Silicon Errata and Data Sheet Clarifications

3.3.1 44-Lead TQFP (PT)

44-Lead Plastic Thin Quad Flatpack (PT) - 10x10x1.0 mm Body [TQFP]

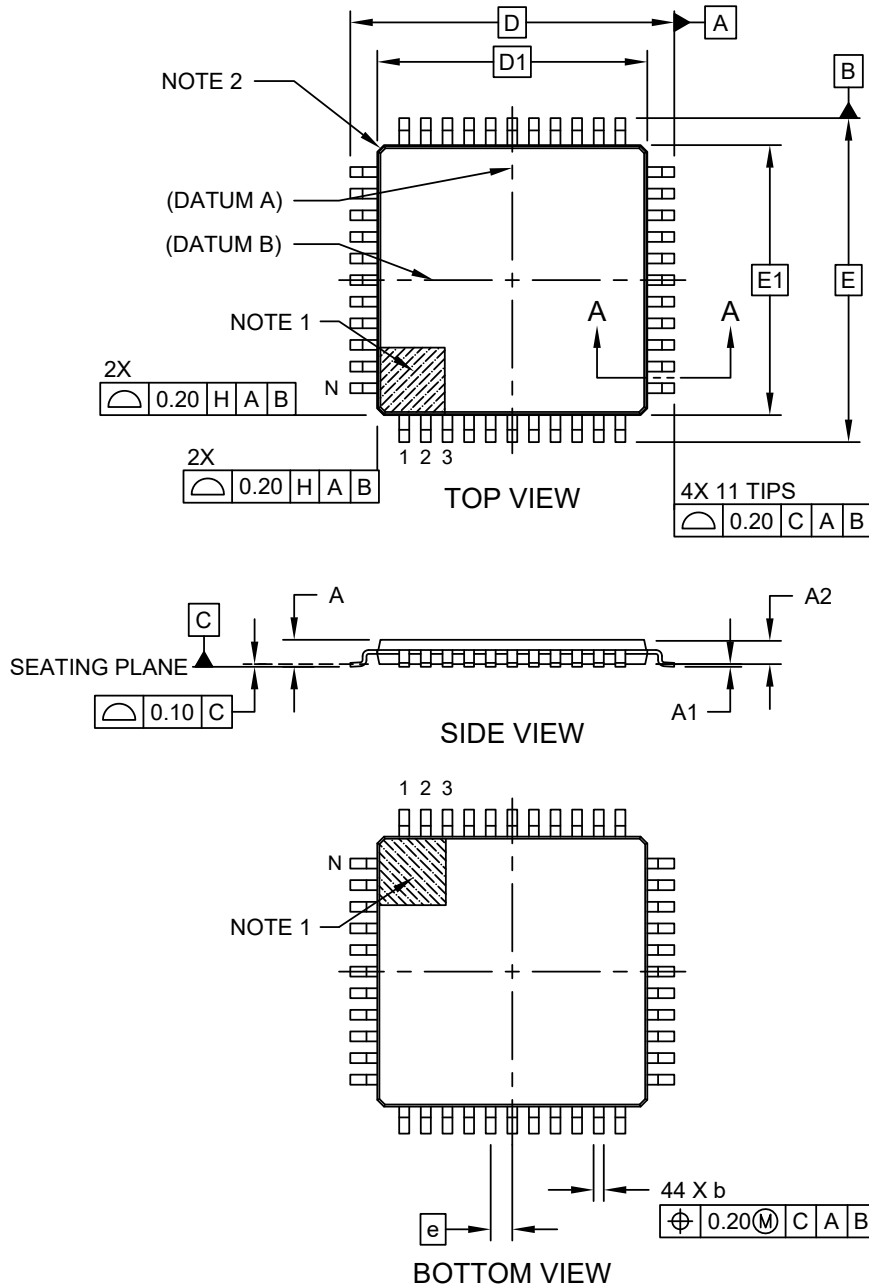
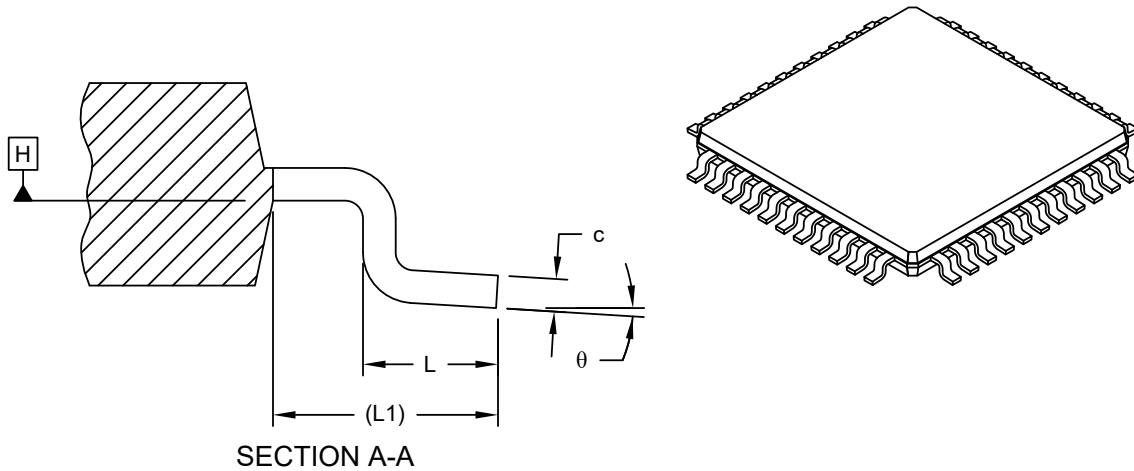
A clarification has been made to replace the VQFP package with a TQFP package.

A drop-in replaceable 44-lead TQFP with the same pinout, footprint, and based on the same die revision replaces the 44-lead VQFP package. There are no functional changes, hence all data sheet specifications are still valid for the replacement CPNs.

The TQFP package outline drawing is shown below.
